This page lists the know errors on the gm5x5x5 PCBs. There are no known issues with the bulk order run (white pcbs), the following information is valid **only** for the prototype run (green pcbs).

#1 Silkscreen error

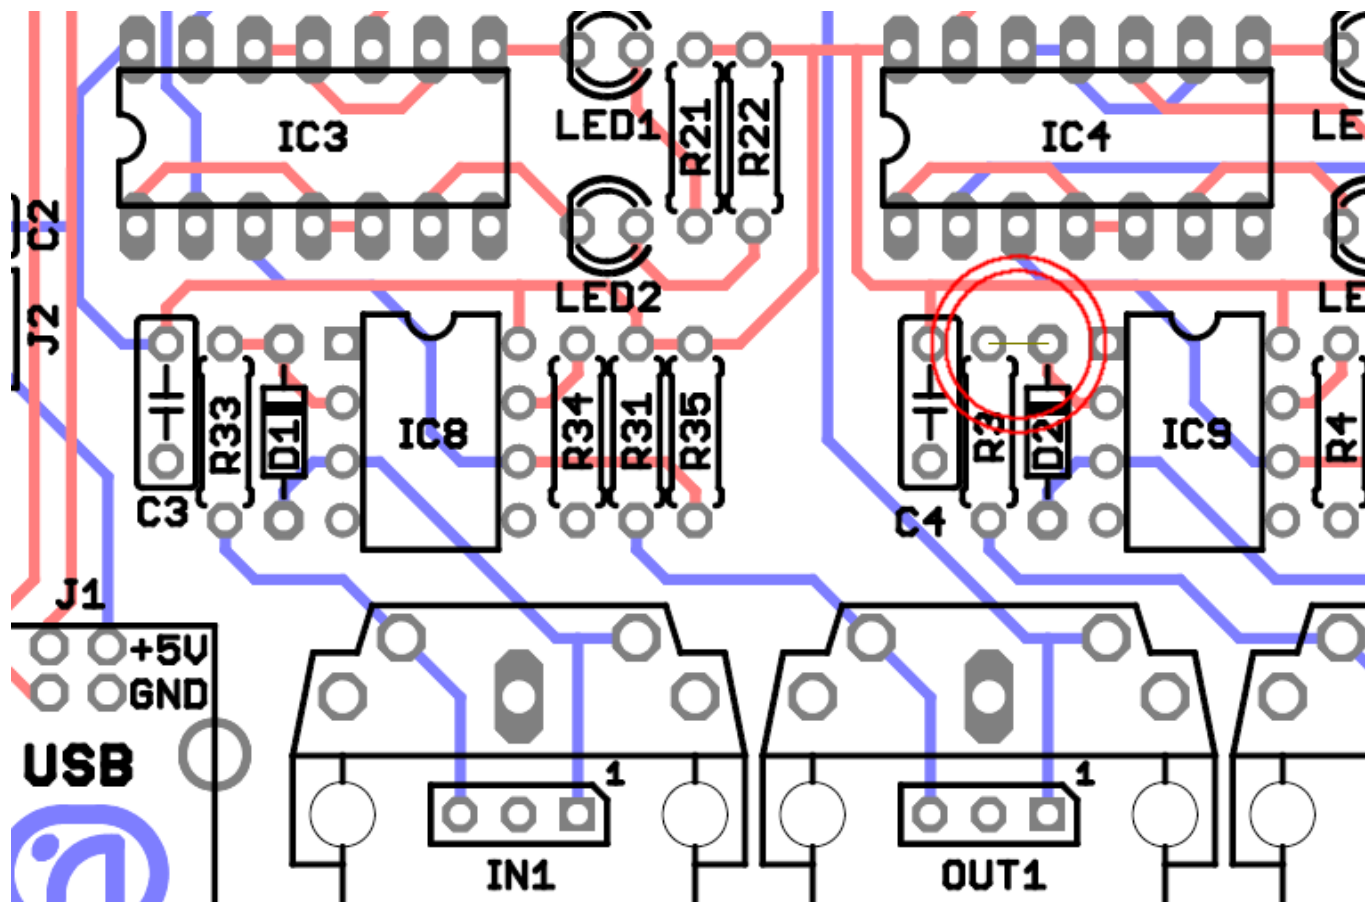
Problem: The silkscreen has the EEPROM the wrong way around - Pin 1 should be facing IC5.

Solution: Stick the EEPROM in the other way around, with the “notch” facing IC5.
